**Technical News 165**  
**October 2015**  
**Strictly Confidential**

<b>Contents</b>		
<b>Item</b>	<b>Subject</b>	<b>Model Affected</b>
Item 1.	Mudguard Extension Australia, India and New Zealand Markets Only	Models With A Mudguard Extension

### Item 3.

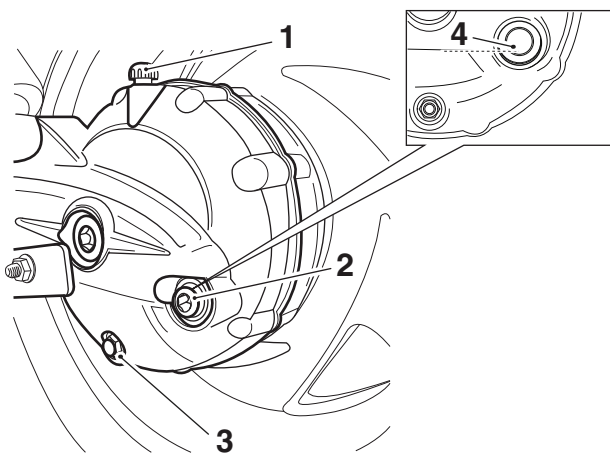
When checking the oil level in the final drive unit during the pre-delivery inspection or service, always ensure the motorcycle is stationary and in an upright position to allow the fluid level to stabilise.

- Clean the area around the breather outlet.
- Remove the filler/level plug (not the lower drain plug) to determine the fill level.
- With the aid of an assistant hold the motorcycle in an upright position.
- Allow any excess oil to drain, the oil level is correct when the oil is level with the bottom of the filler.
- Refit the oil filler/level plug and tighten to **60 Nm**.

1. Breather outlet
2. Filler/level plug
3. Final drive unit (silencer removed for illustrative purposes)
4. Oil level mark

## Item 6.

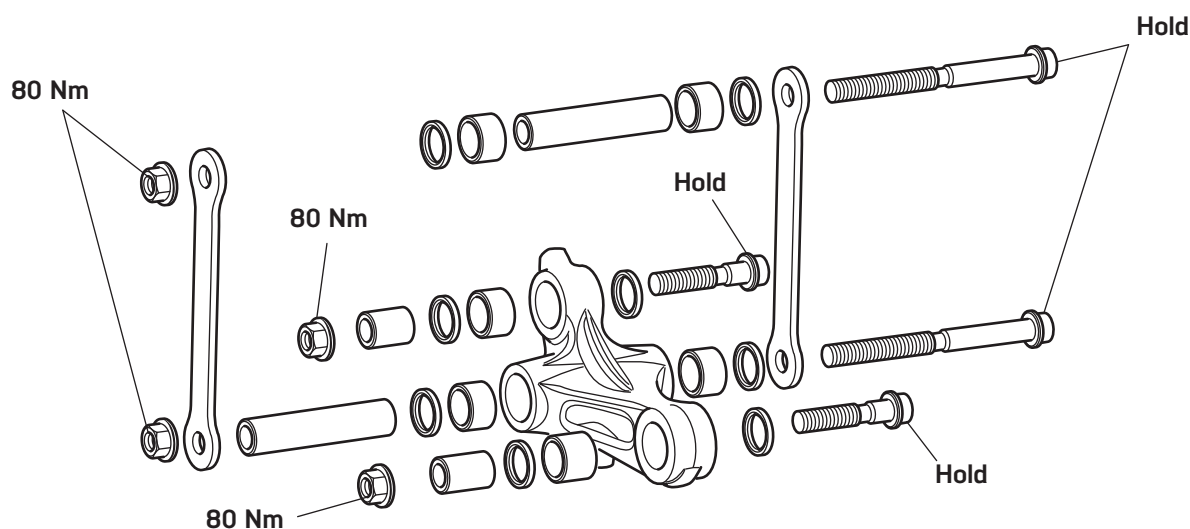
When installing the rear suspension drag link and drop links on the above models, follow the procedure described in the Service Manual noting the following:

- When tightening the drag link and drop link fixings, hold the bolts to prevent rotation, while tightening the nuts to **80 Nm**.

Always ensure during rear suspension linkage assembly that the linkage bolts are held while the nuts are tightened to **80 Nm**.

**Item 8.**

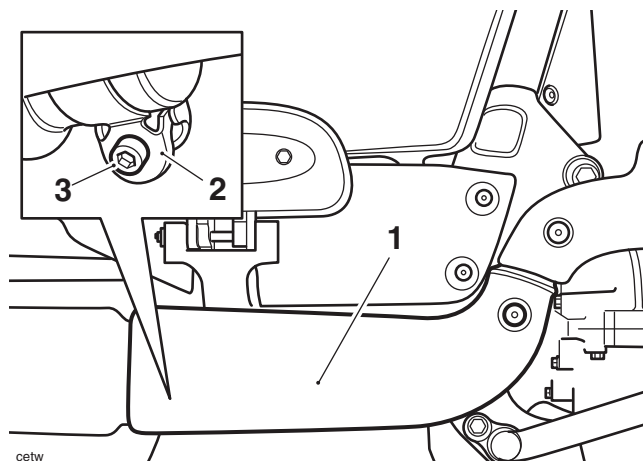
The torque figure for the silencer heat shield clamp fixings has changed to **5 Nm** on the above models.

1. Silencer heat shield (right hand shown)
2. Clamp
3. Fixing

**Item 9.**

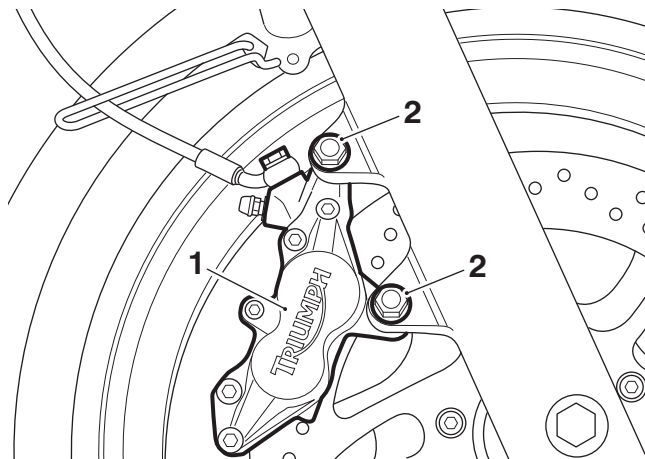
We have introduced the application of a high temperature copper-based grease to the threads of the front brake caliper bolts on the above models from VIN 723736.

- Prior to fitment, lubricate the threads of the caliper bolts using a minimum amount of proprietary high temperature copper-based grease.

1. Caliper (Thunderbird shown)
2. Bolts

### Item 11.

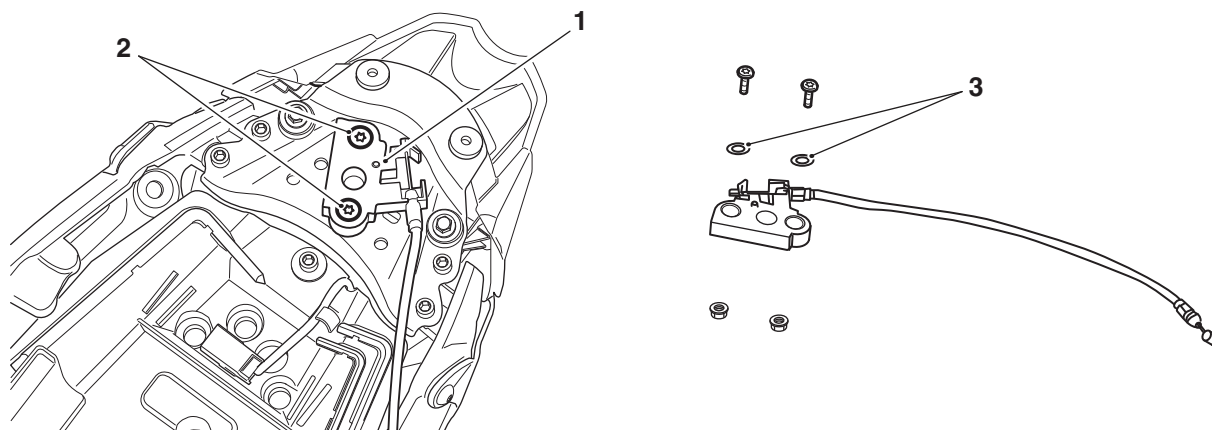
The torque figure for the seat latch fixings has changed to **5 Nm** on the above models.  
Washers have also been introduced to the seat latch fixings on the above models from VIN 718549.

1. Seat latch
2. Fixings
3. Washers

### Item 12.

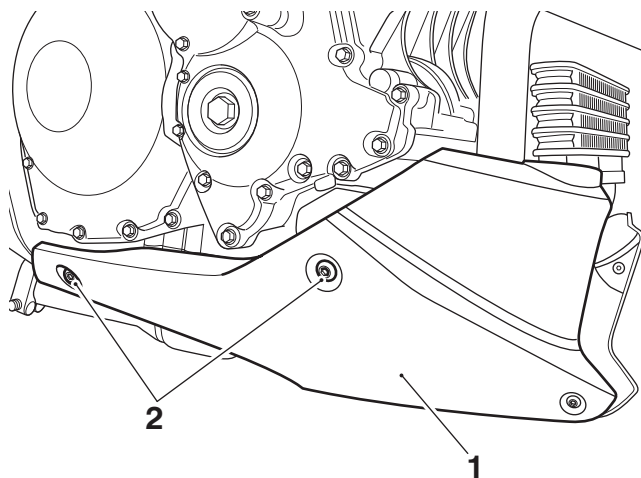
The torque figure for the belly pan fixings has changed to **10 Nm** on the above models.

1. Belly pan (right hand side shown, left hand side similar)
2. Fixings

**Item 13.**

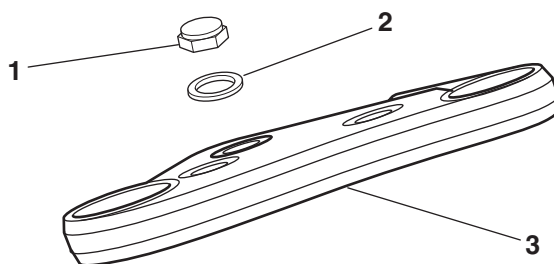
A 3.2 mm thick washer has been introduced to the above models from VIN 724298 and is retrofittable. The washer is located between the yoke and the top cap. The torque figure for the top nut remains at **65 Nm**.

- 1. Top nut
- 2. Washer, 3.2 mm
- 3. Top yoke
